**SERVICE BULLETIN**

SB No. 95 Issue No. 1

TITLE INSPECTION OF THROTTLE CABLE MOUNTING BRACKET

FIG 1  
THROTTLE CABLE FLUID MOUNTING

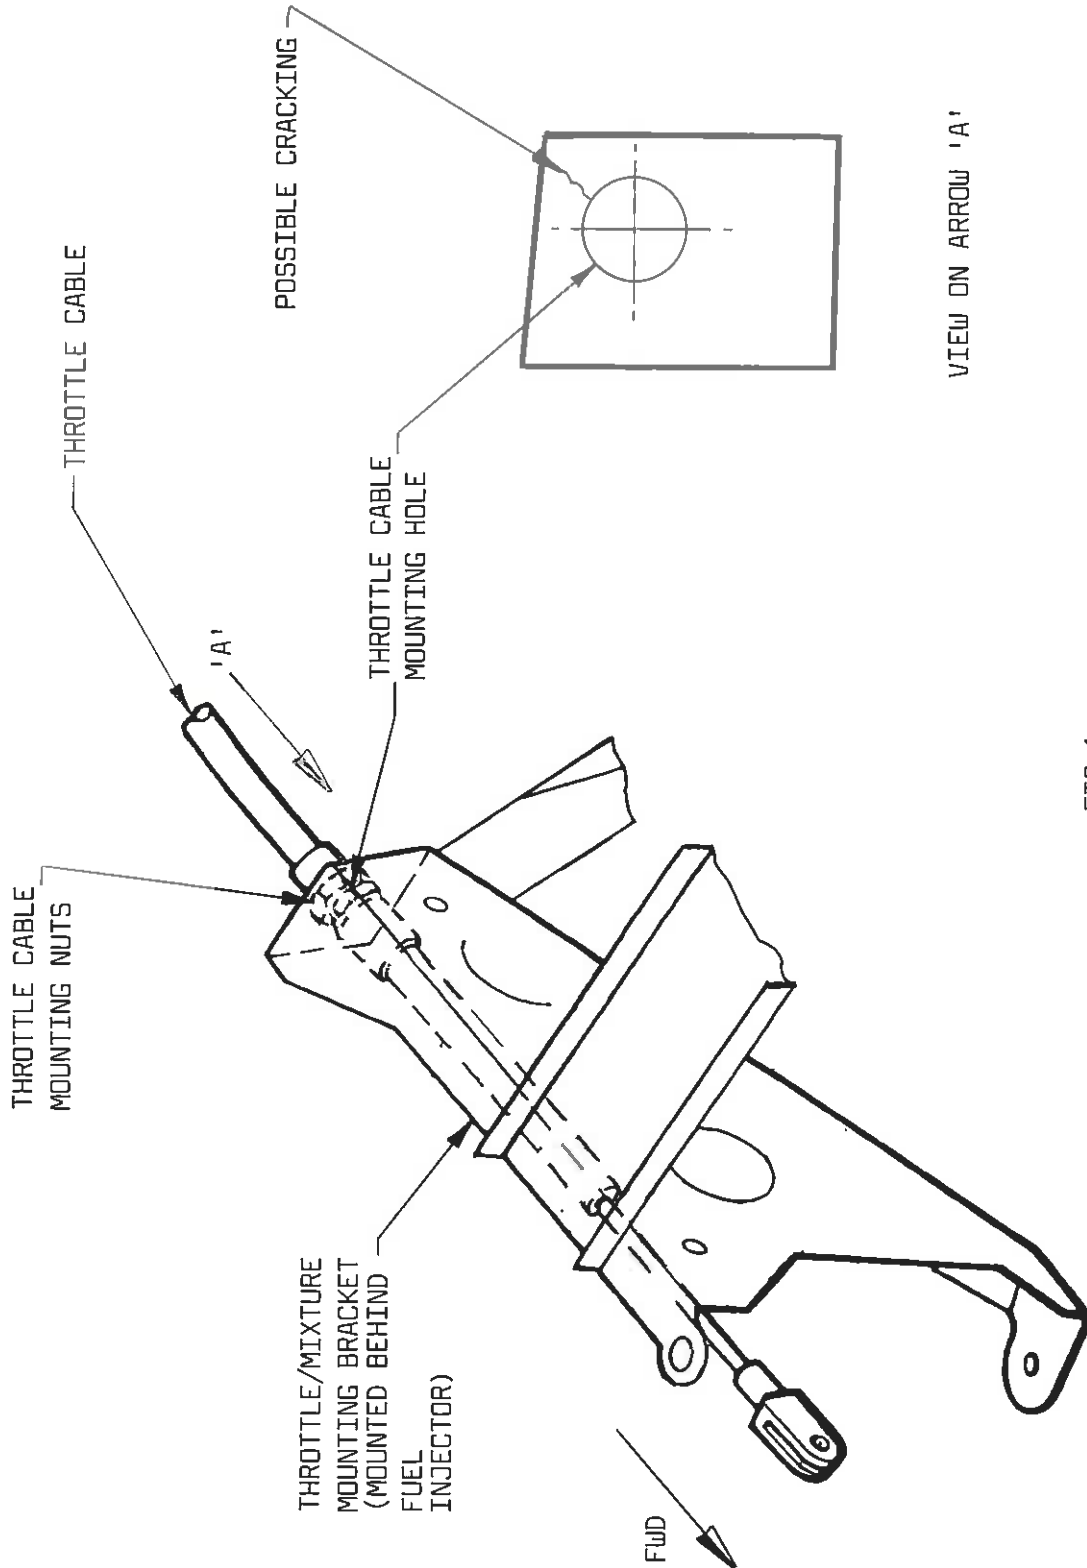
A case has been reported of cracking at the throttle/cable attachment position on the throttle/mixture cable mounting bracket, positioned behind the fuel injector.

1. Disconnect throttle cable mounting nuts. Ref Fig. 1.
2. Inspect for cracks around mounting hole. Ref View on Arrow 'A'.
3. If no cracks are found reassemble.
4. Annotate in logbook SB 95 complied with.
5. If cracks are found, replace throttle/mixture mounting bracket T67M-50-233. Report findings to SAL.
6. Annotate in logbook SB 95 complied with.

For replacement bracket T67M-50-233 contact SAL Product Support Department.
